Hope Downs 4 Iron Ore Project

Response to Submissions

Response to submissions

Client: Hamersley HMS Pty Ltd

1.2.1 Amended tenure figure

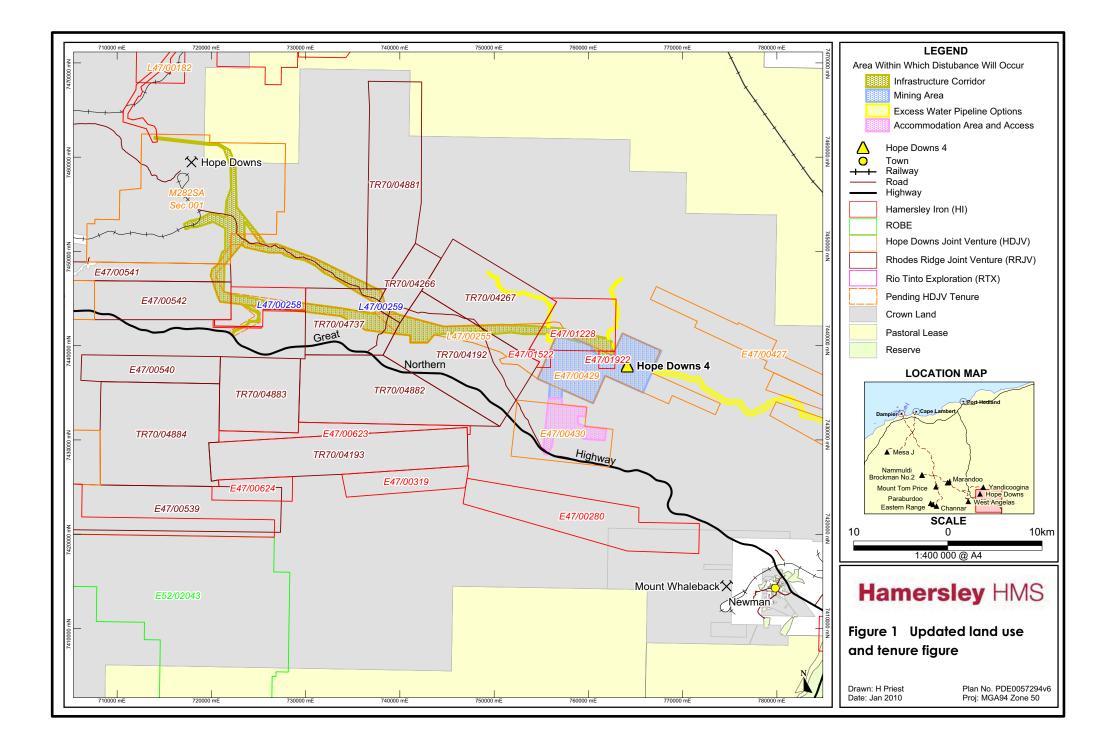
Figure 10 (Land use and tenure) in the PER has been amended following responses from surrounding landholders identifying that land tenure was not correctly described. This amended tenure figure is included here as Figure 1. The changes to this figure do not have any implications for the environmental impact assessment presented in the PER.

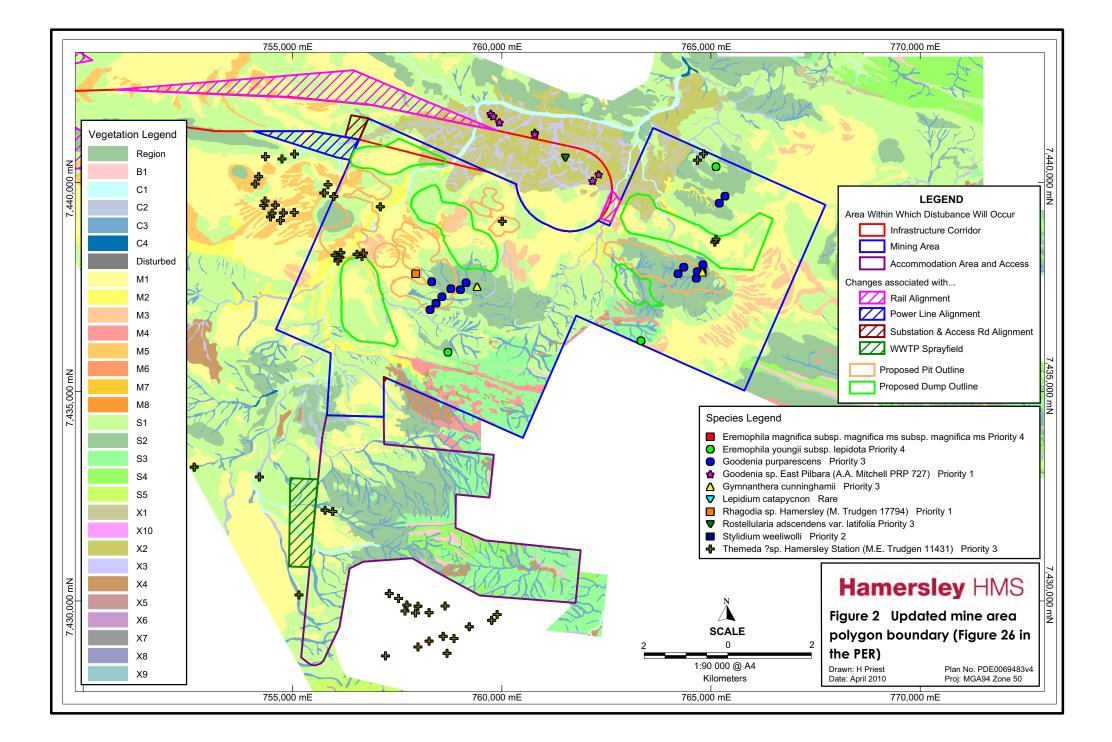
The proposed mine area component polygon has been slightly modified to accommodate two small additions to the mine area without increasing the requirement for total clearing. These changes include:

Changes to the proposed accommodation and access area component polygon comprise of an expanded area to the west of the camp/village without increasing the requirement for total clearing. The changes to this area are required to cover relocation and optimisation of the spray field associated with the waste water treatment plant. The relocation of the spray field has optimised avoidance of the M1 mulga community.

The amended area is illustrated in Figure 2.

The amended area is illustrated on Figure 2.

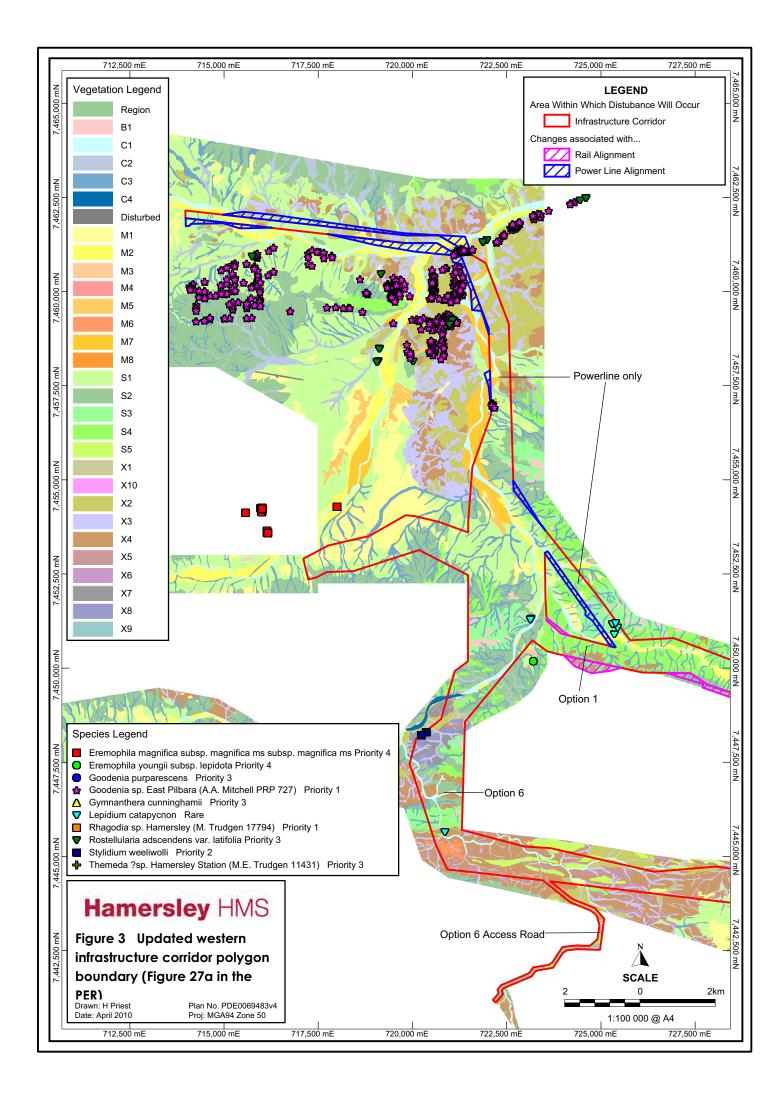
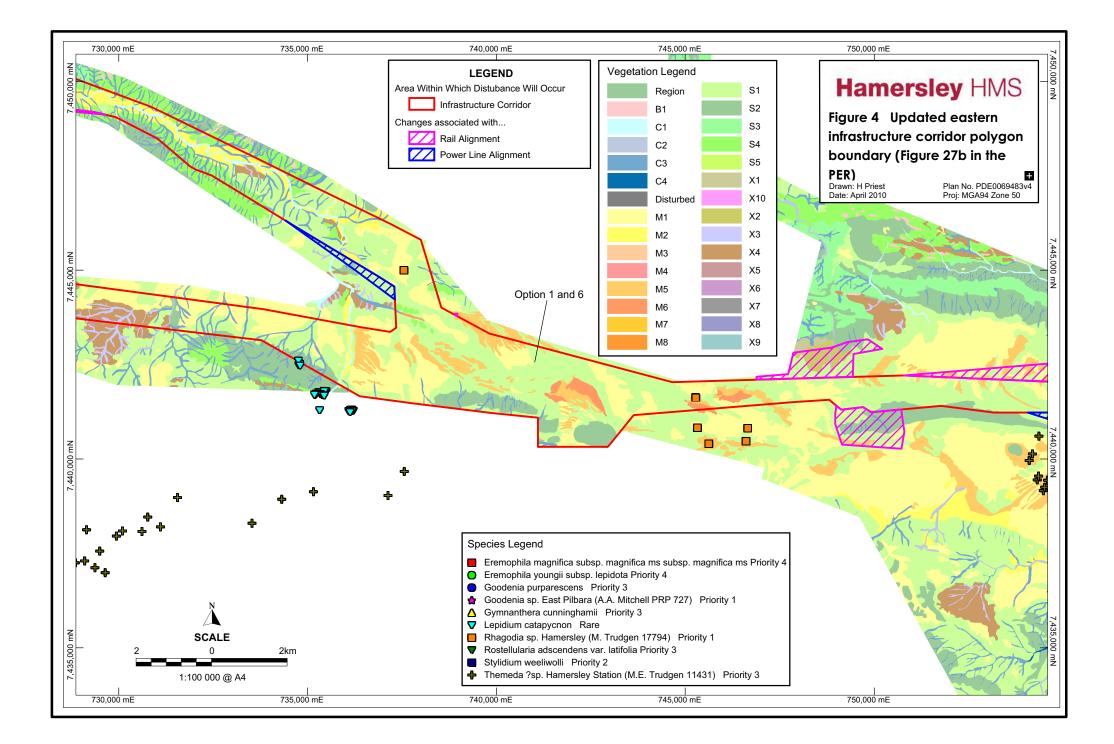
Changes to the proposed infrastructure corridor component polygon have been made to accommodate refinements to the rail and power related requirements for the Proposal without increasing the requirement for total clearing. These changes include:

- an area at eastern end of the power corridor to optimise the construction laydown and support areas so as to avoid heritage sites identified during surveys
- areas at the north western end of the power corridor on the HD1 mining lease. Due to the occurrence of Priority Flora in this area of the corridor a larger area is required to provide the opportunity to optimise the detailed design of the area to allow for the avoidance of Priority Flora
- along the north south segment on the HD1 mining lease, the additional polygon areas allow optimisation of the construction and maintenance access needs from existing access points (i.e. reduce clearing requirements)
- along the east west segment between HD1 and in the vicinity of Rhodes Ridge, the additional polygon areas are required to allow for the optimisation of the rail alignment through this sector.

- several areas along the western end of the rail corridor to facilitate the realignment of the existing public road and installation of appropriate signalling equipment
- one area to the west of the corridor to optimise the avoidance of several significant heritage sites identified during surveys
- an area to the west of the corridor to reduce the impact to a creek system and improve the underpass crossing of the existing BHPB power line
- several areas to the east of the corridor to obtain good quality borrow material
- an area associated with the Coondiner Creek area to facilitate a lower impact creek crossing; the new location avoids the need for two crossings of Coondiner Creek and results in a shorter bridge length
- an area to the east of the rail loop to facilitate construction access between the rail corridor and the mine area.

The amended areas are illustrated on Figure 3 and Figure 4.

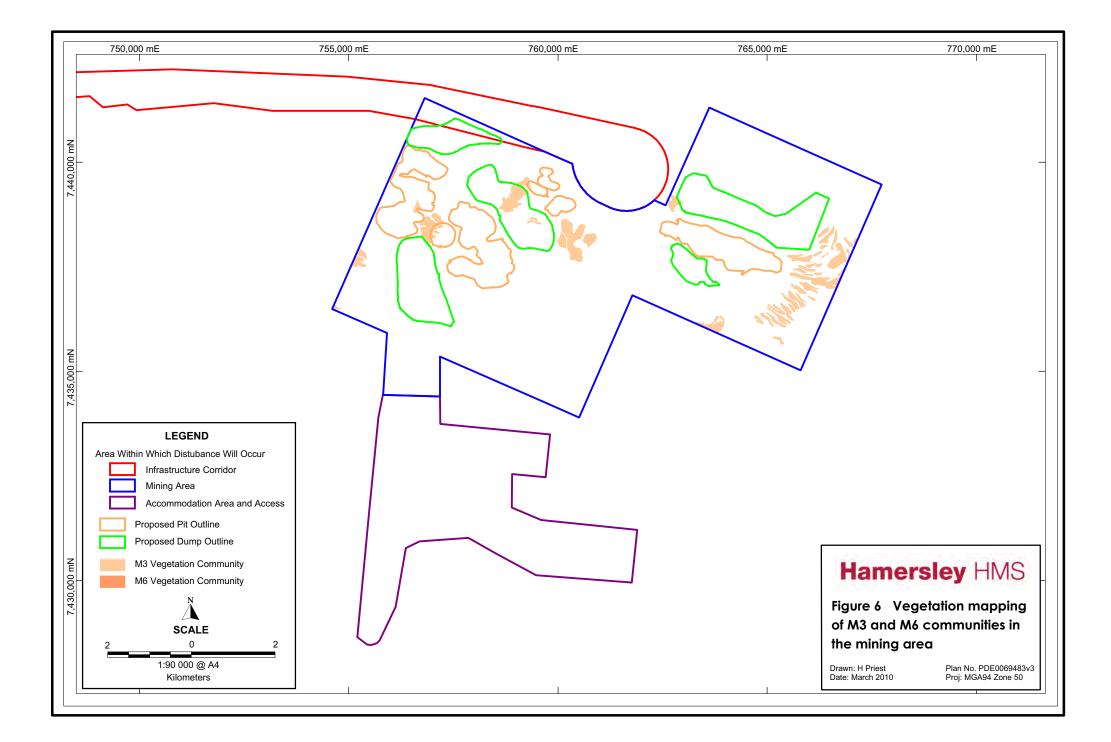
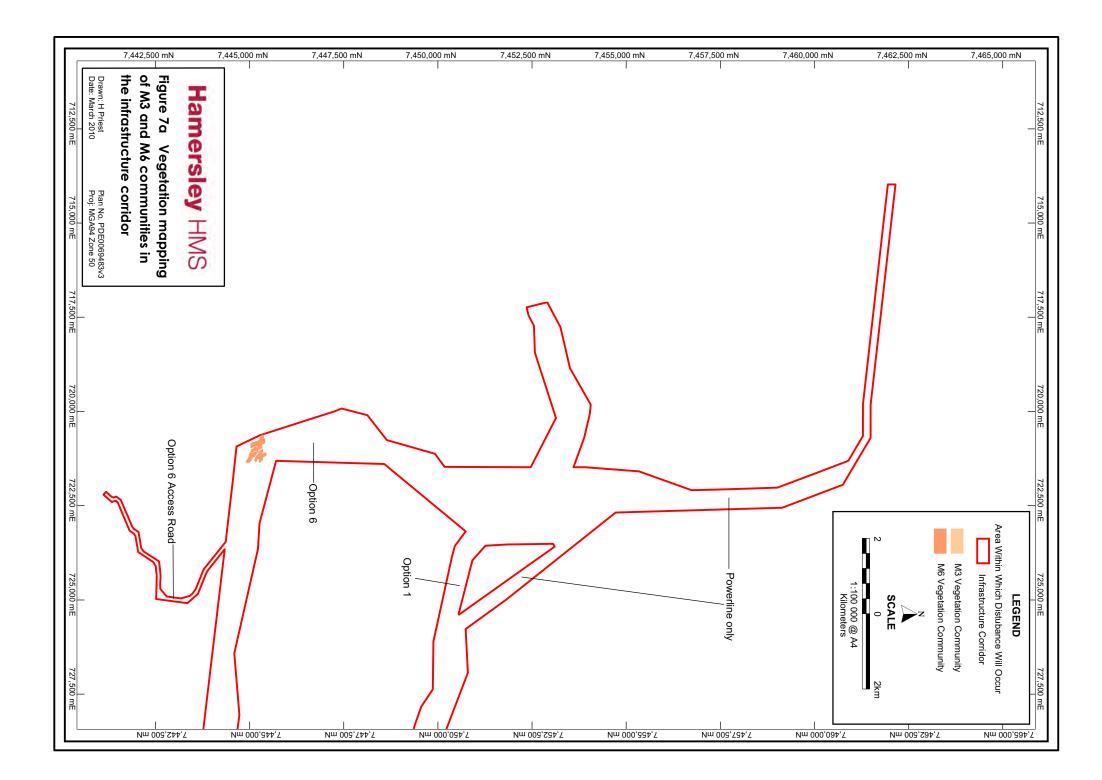
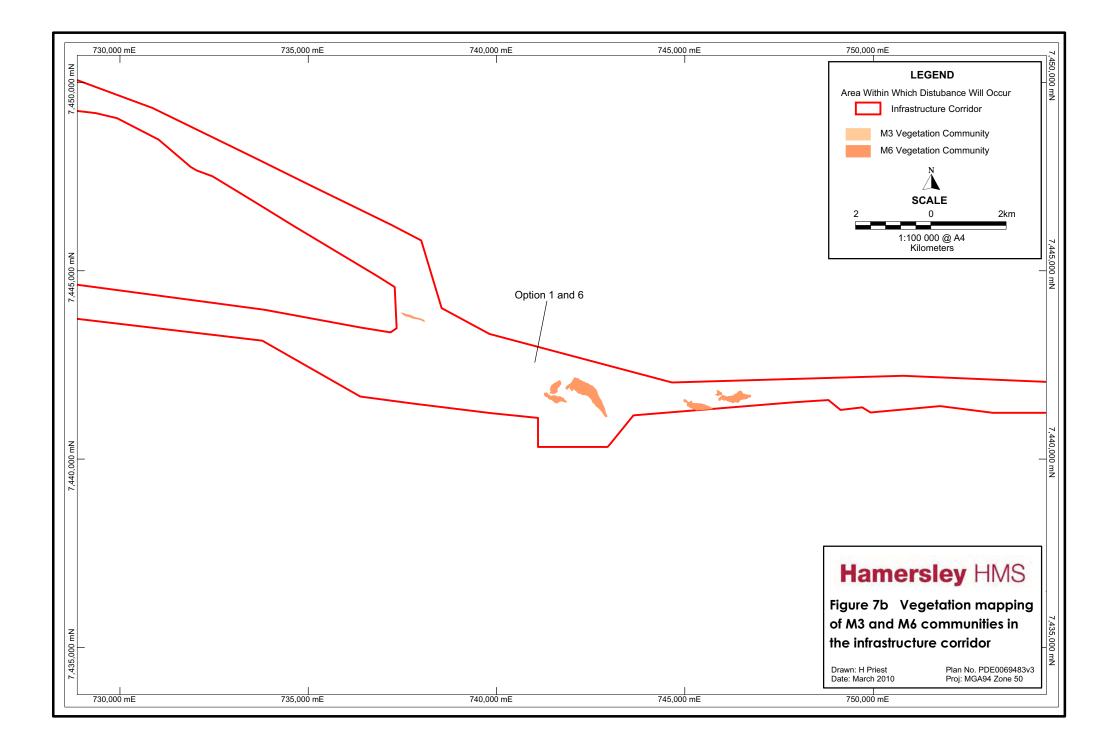
It its submission on the PER, the DEC commented that the conservation status of vegetation communities M3 and M6 was unclear and could be similar to the Priority Ecological Community (PEC) 'Brockman Iron cracking clay communities of the Hamersley Range' (Priority 1). DEC also commented that the communities needed to be more clearly defined on figures included in the PER (refer to Item 6 of Table 4 for full submission).

Clarification from DEC in regard to their comments, and detailed floristic data of the PEC, was sought from Stephen van Leeuwen, DEC Principal Research Scientist, in order that a floristic analysis could be undertaken by Mattiske (Appendix 4). In a reply by email (22 March 2010), Stephen van Leeuwen stated that the DEC was unable to provide floristic data on the PEC and rephrased the DEC request. Specifically, the DEC requested:

- the species list from quadrats in each of the M3 and M6 vegetation structural types
- better vegetation maps at an appropriate scale and resolution.

To satisfy the DEC request the following tables have been provided:

- species by M3 and M6 communities: Table 1 in Appendix 4 describes the species present in vegetation communities M3 and M6 and reflects the degree of abundance in the respective sites
- species within the M3 and M6 communities by site: Table 2 in Appendix 4 includes the species present at each survey location located within vegetation communities M3 and M6
- vegetation maps: A0 size copies of the vegetation maps have been provided to OEPA with submission of this Response to Submissions document for provision to the DEC.

The mapped extent of these vegetation communities has been presented in Figure 6 to Figure 7b. Both vegetation communities are well represented outside the Proposal component polygons. Less than 25% of the mapped extent of both communities is within the Proposal component polygons (93 ha of 282 ha for the M6 community and 270 ha of 1084 ha for the M3 community).

Figure 1. The two pathways of signal recording (blue arrows), with influences or modifications indicated (red arrows).

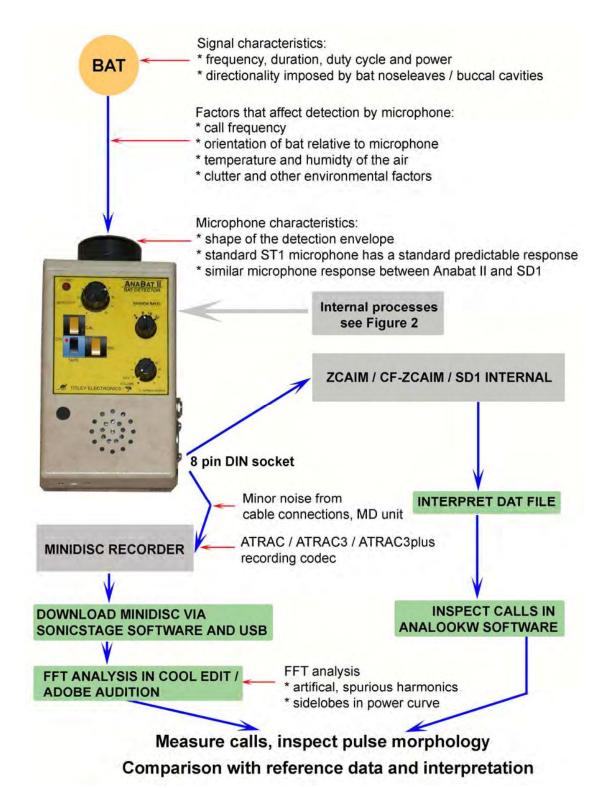
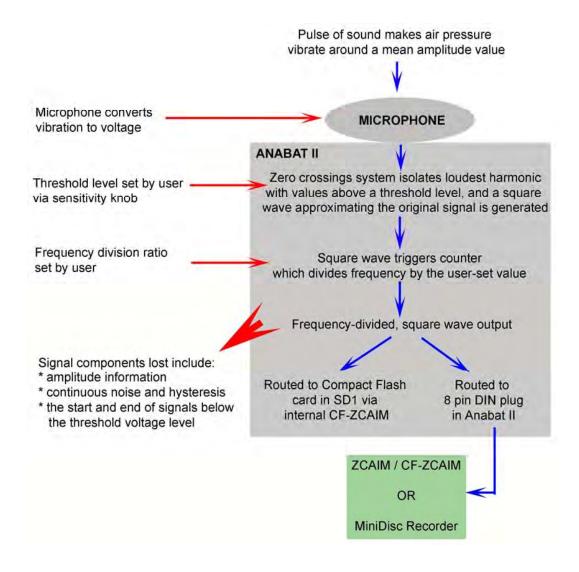
In order to justify my comment that the method of McKenzie and Bullen is based on a fundamental misunderstanding of how the Anabat system works, I have provided a schematic diagram (Figures 1 and 2) and several statements that explain the system, which underpin all of the following comments made in this response letter.

It is inaccurate to state that Anabat II – MiniDisc recordings "capture all ultrasonic echolocation". The signal available to the MiniDisc recorder has been modified by several processes (Figure 1), and will only convert ultrasonic bat calls that are above the threshold determined by the sensitivity setting (Figure 2). As has been explained, the Anabat II output that is available to the ZCAIM and the MiniDisc recorder is exactly the same.
